Tesla, Inc. Service Bulletin		<h2><i>Inspect and Rework Front Aero Shield</i></h2>	
SB-24-12-009 November 29, 2024			
Classification		Section/Group	Mobile Service
Repair Bulletin		12 - Exterior Fittings	Cannot Perform
Model	Model Year	Country/Region	Build Location
Model 3	All	EMEA	Giga Berlin, Giga Shanghai
Model Y	All		
<small>The model(s) and model year(s) listed are a general approximation of the affected VIN list. Refer to the VIN/Bulletin Tracker or Customer/Vehicle profile to determine applicability of this bulletin for a particular vehicle.</small>

Condition

Figure 3

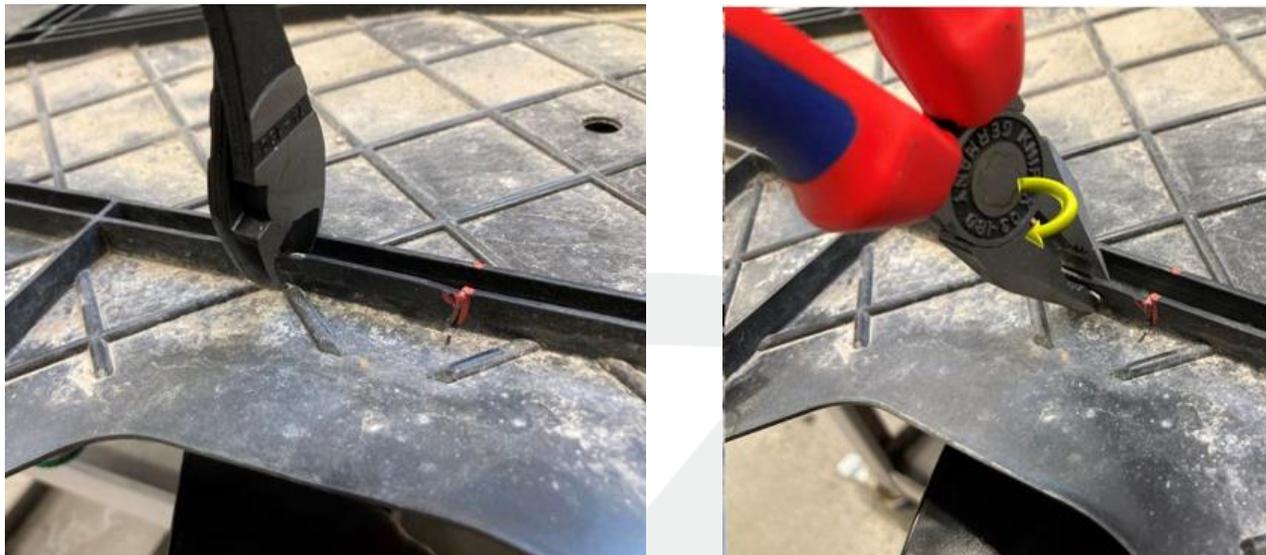
3. Cut out the reinforcement area of the front aero shield between the marked point (Figure 3).
 - a. Use a side cutting plier to cut the material at the marked points
 - b. Use a combination plier to remove the remaining material between the marked points
